ADDENDUM NO. 1

HC Wheatley Institute 3<sup>rd</sup> Floor

## **Project: Wheatley Institute – 3<sup>rd</sup> Floor Renovation**

### **ADDENDUM NO. 1**

**M9243**  
**A1.1**

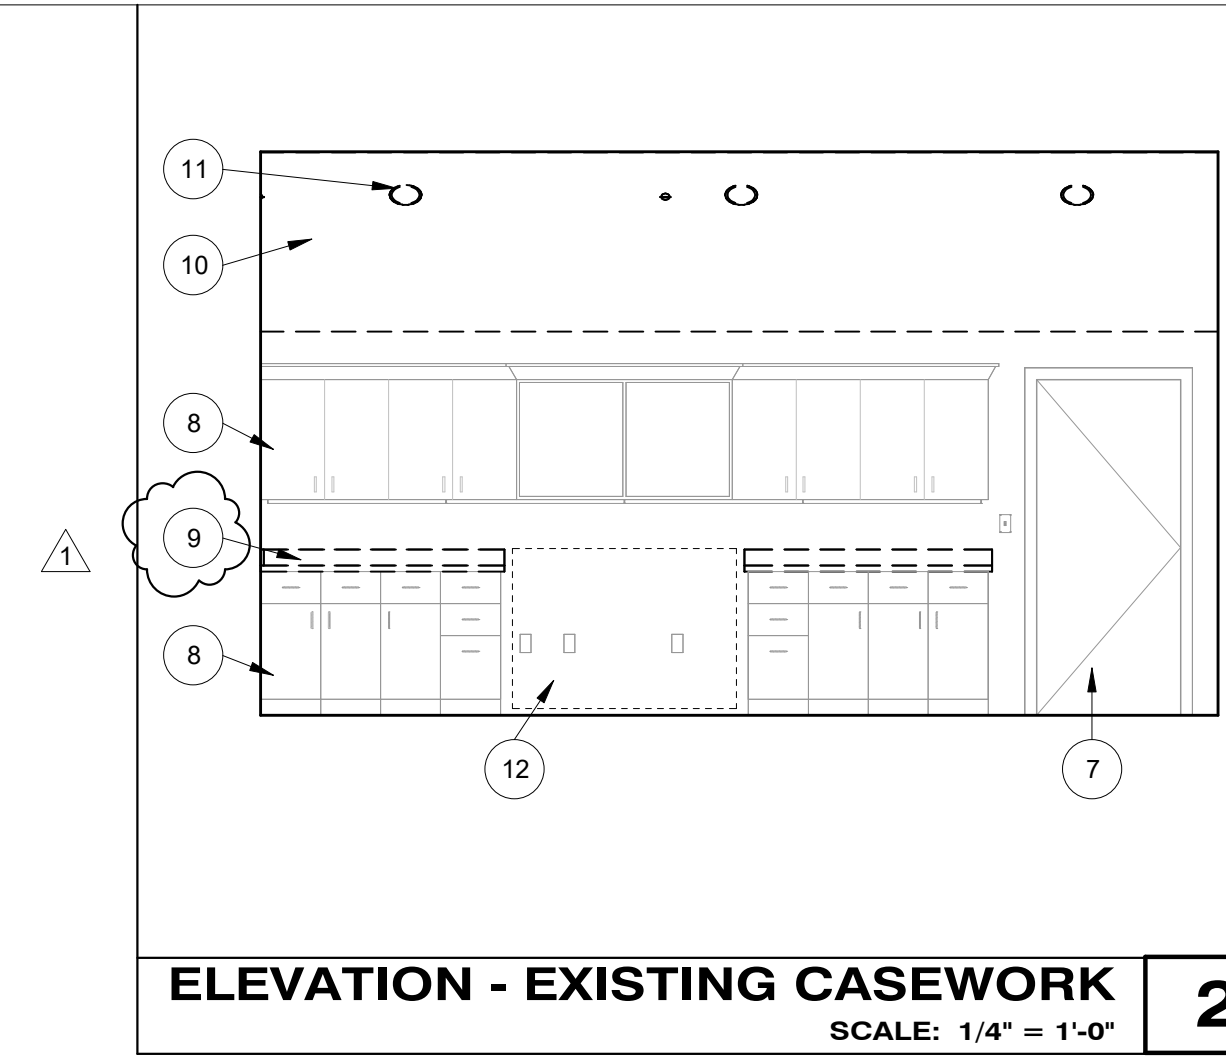
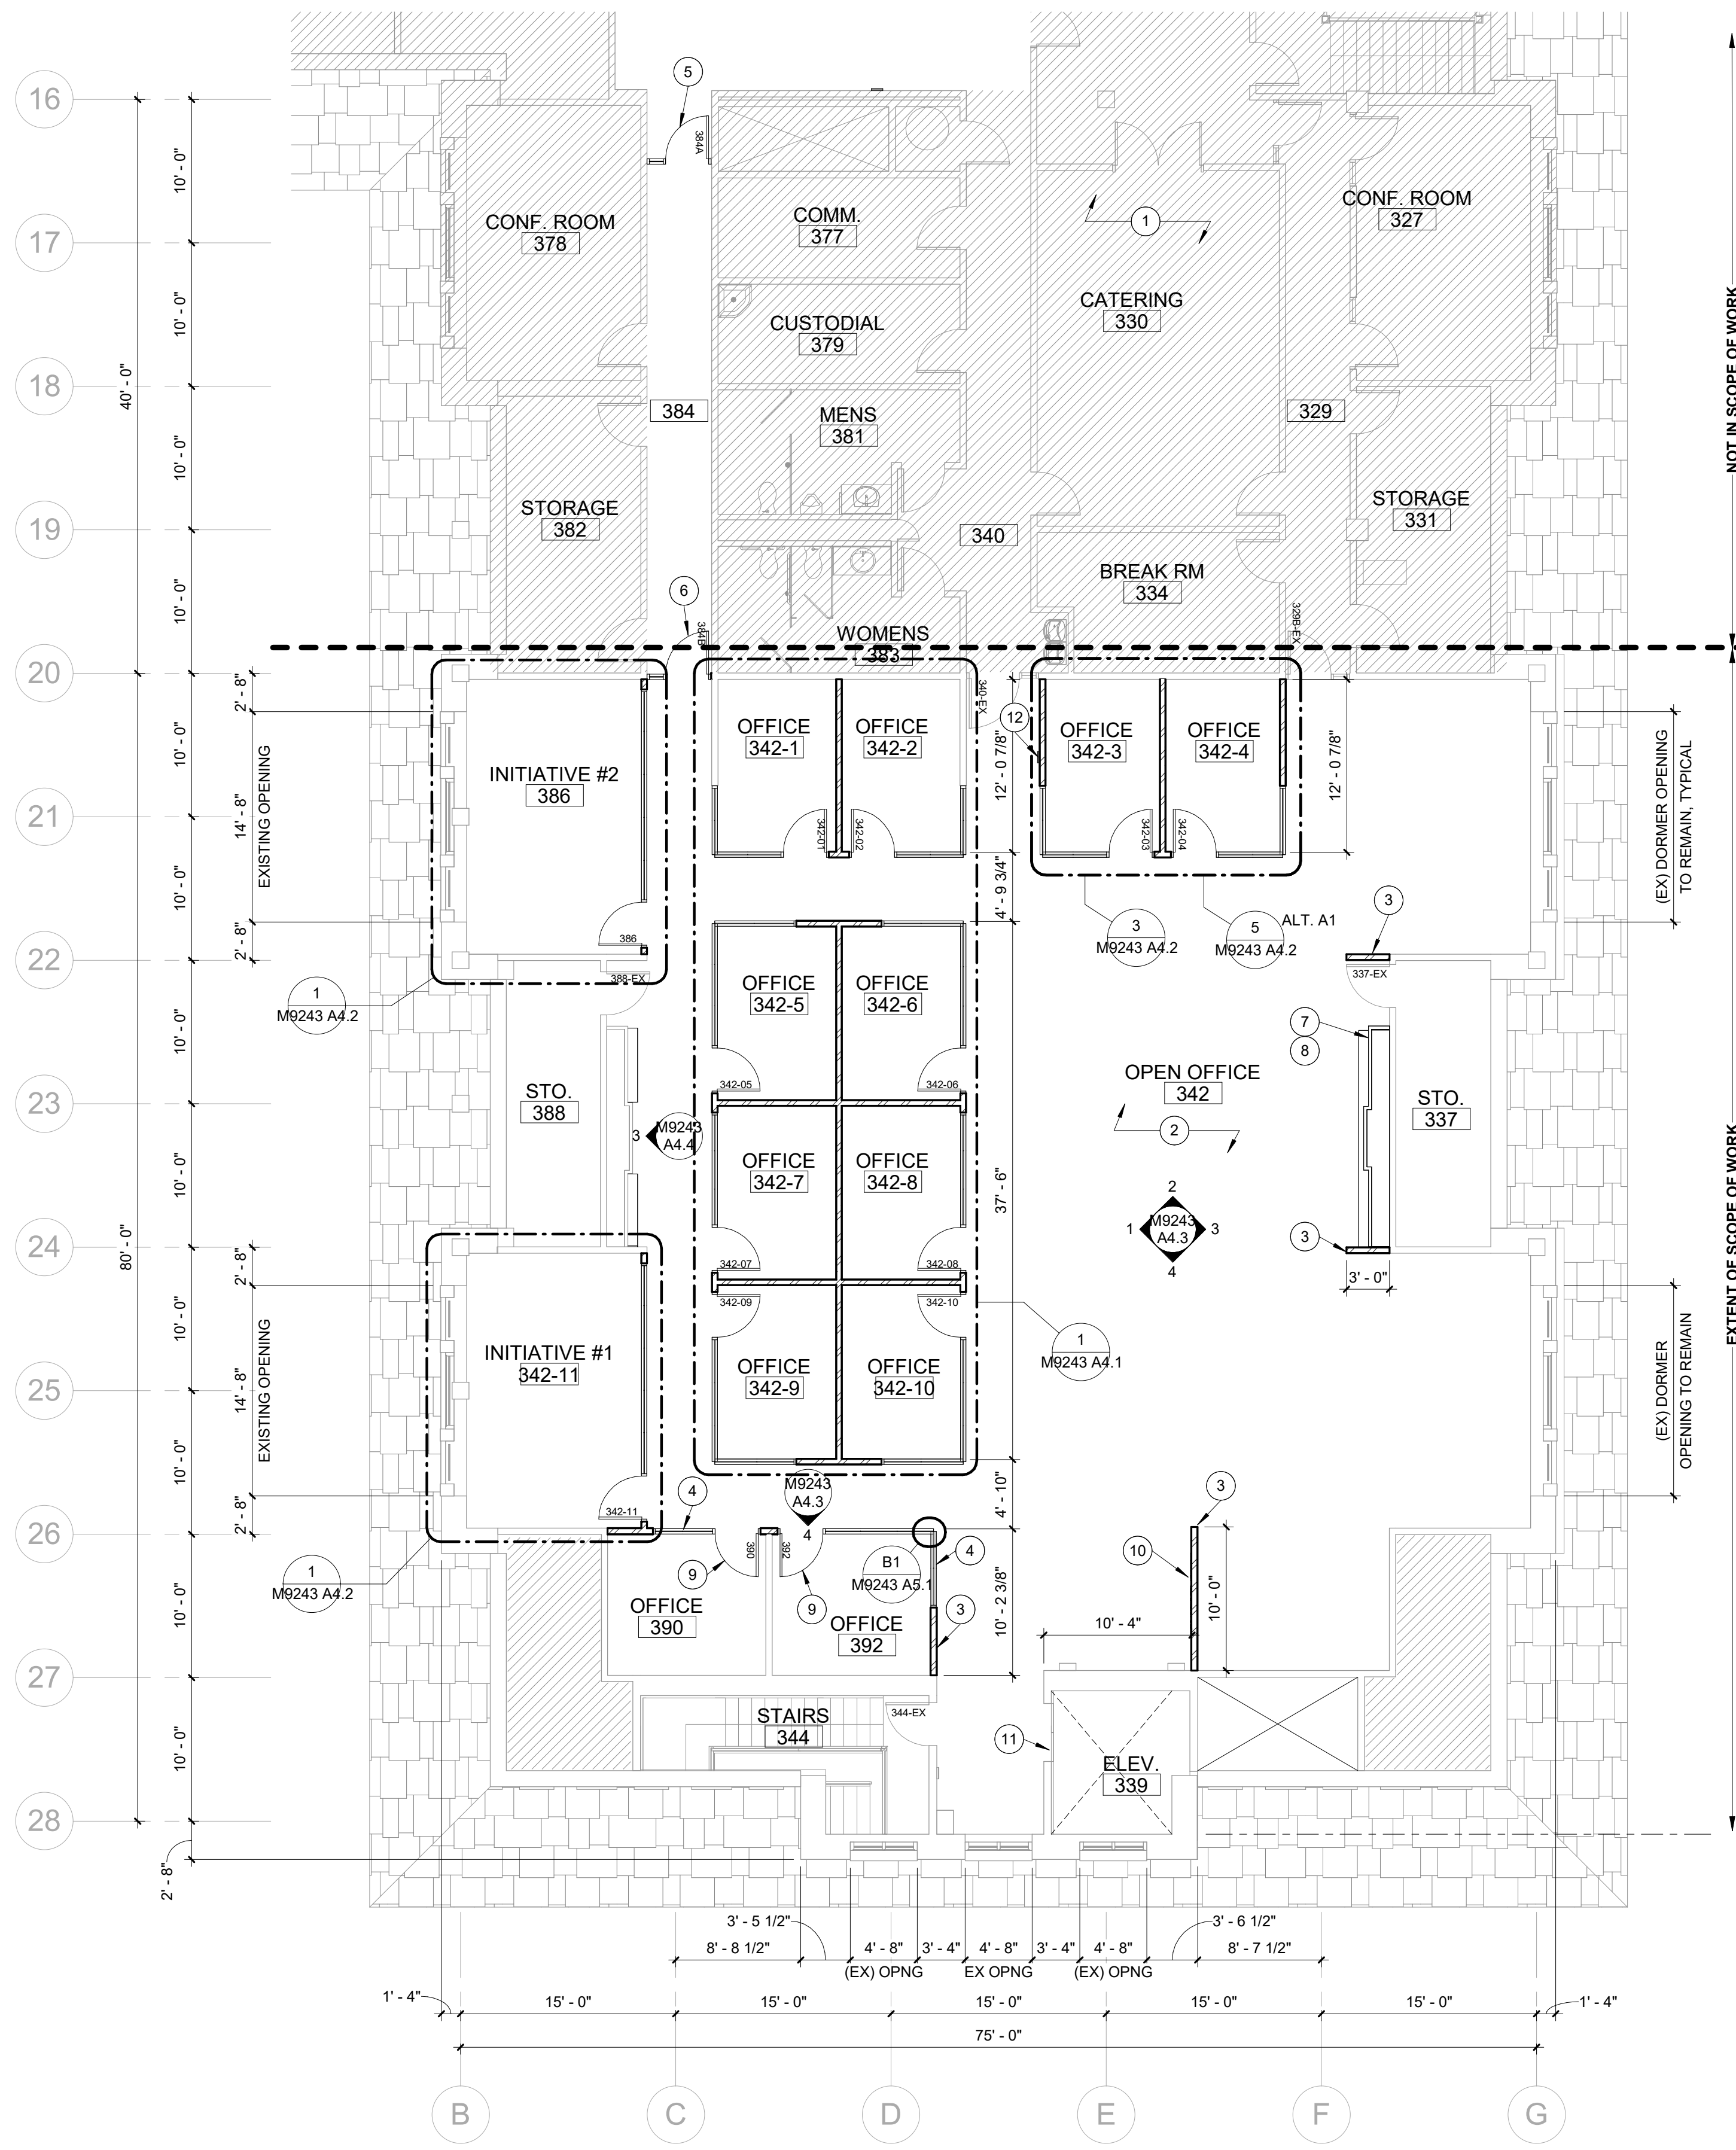
3. **Sheet A1.1**
  - ADD: Sheet keynotes 15 to show Fire Extinguisher Cabinet to be removed and relocated to adjacent new wall.
  - REVISE: Sheet keynotes 2, 4, 5, 9, 13, & 14 to clarify scope and responsibility.

- EXISTING FIRE EXTINGUISHER CABINET TO BE REMOVED AND RELOCATED IN NEW WALL AS INDICATED ON PLAN.

WORK ORDER & SHEET NO.  
**M9243**  
**A1.3**

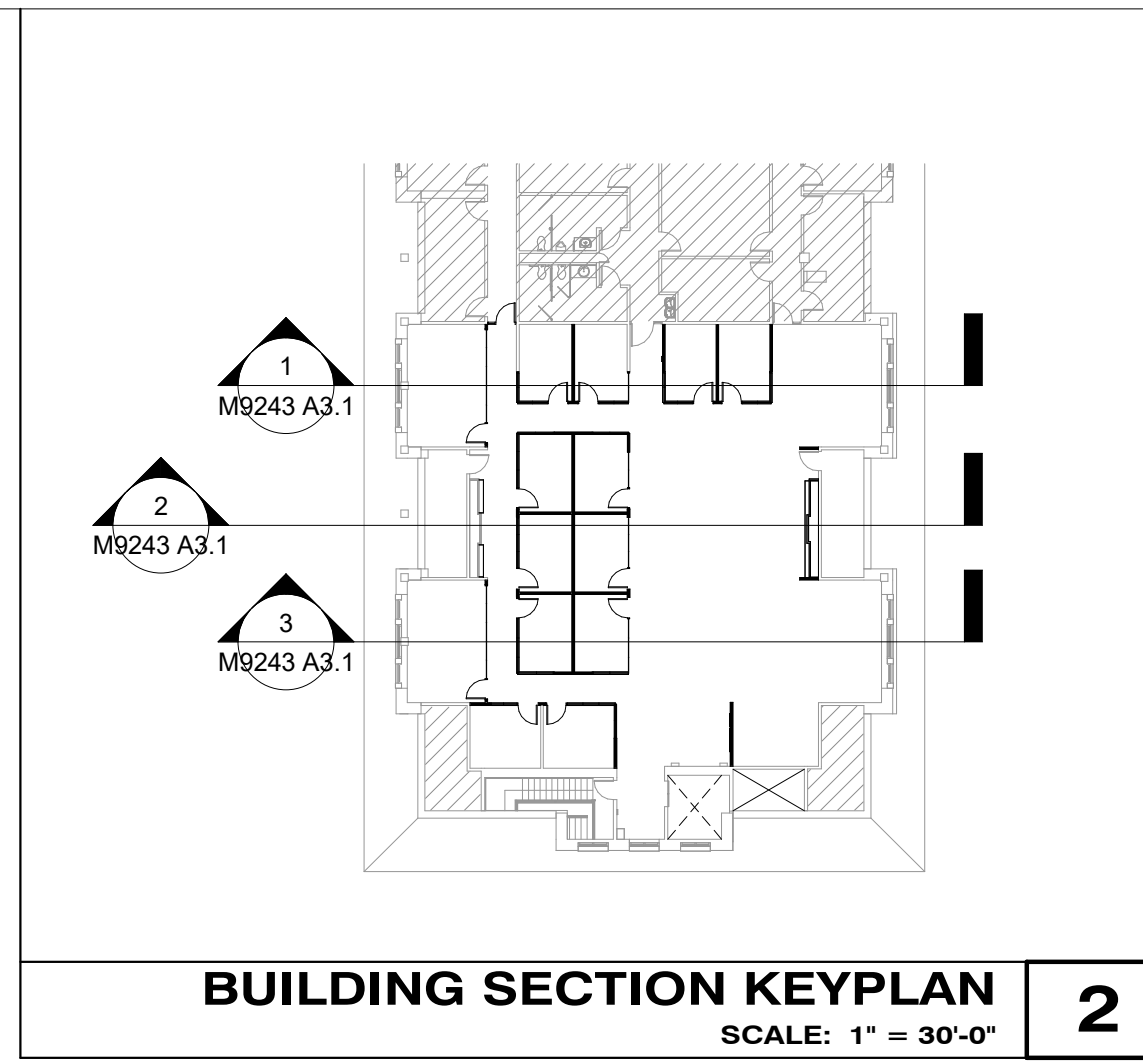
4. **Sheet A1.3**
  - ADD: Sheet keynote 12 for relocation of existing Fire Extinguisher Cabinet.
  - ADD: Note 12 on floor plan showing new location for the Fire Extinguisher Cabinet.

- CONTRACTOR TO PROVIDE PROTECTION OF ALL SURFACES WITHIN ELEVATOR CAR AND ELEVATOR ENTRANCES.
  - RELOCATED FIRE EXTINGUISHER CABINET.
